2006 INTERNATIONAL FIRE CODE

Code Change No: **F84-07/08**

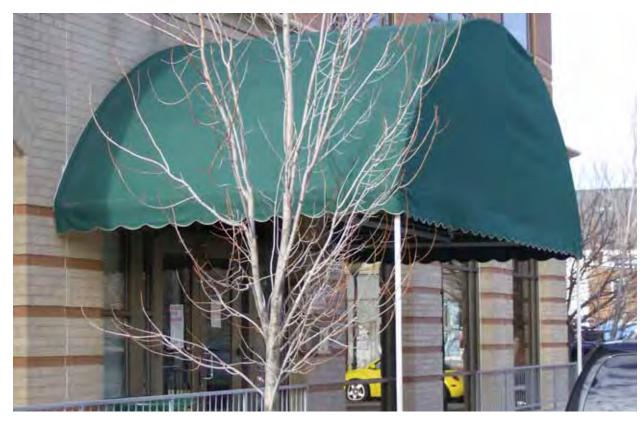
This photo fits the definition of a canopy, and at the same time, fits the building code definition of a tent:

The above photo is also addressed in the fire code as a canopy but it doesn't fit the fire code definition.
